**APPLICATION FOR DEVELOPMENT APPROVAL
PROPOSED CHILD CARE CENTRE
LOT 1 (No.2C) MATHESON ROAD, APPLECROSS**

We refer to the above-described Development Application ('Application') and hereby respond to the various items outlined in your emails dated 21 December 2020 and 15 January 2021, following assessment and advertising of the Application.

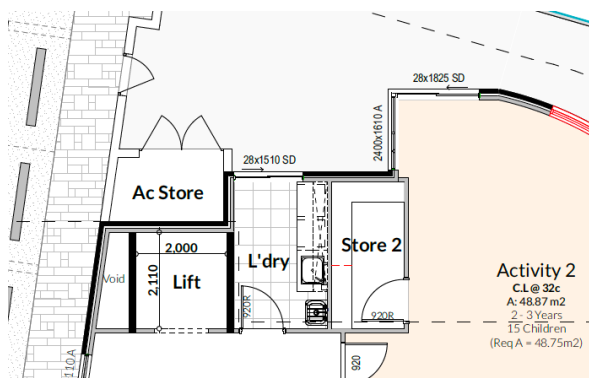
Location of Air Conditioning Units and Other Utilities

As depicted on the Architectural Drawings submitted with the Application, an air conditioning plant room is proposed on the Ground Floor. The plant room is integrated into the design of the building and situated adjacent to the lift. The plant room will contain the air conditioning condenser units and is enclosed with solid walls on three sides. The doors will have louvers for ventilation and face toward Canning Highway. The plant room design and location ensure it will not have an adverse visual or noise impacts. Air conditioning ducting will be housed within the 'void' at the rear of the plant room, adjacent to the lift, avoiding the need for any ducting to be affixed to the external walls of the building to enhance its appearance. The 'void' is of sufficient size to accommodate other services (i.e. electrical, hydraulic etc).
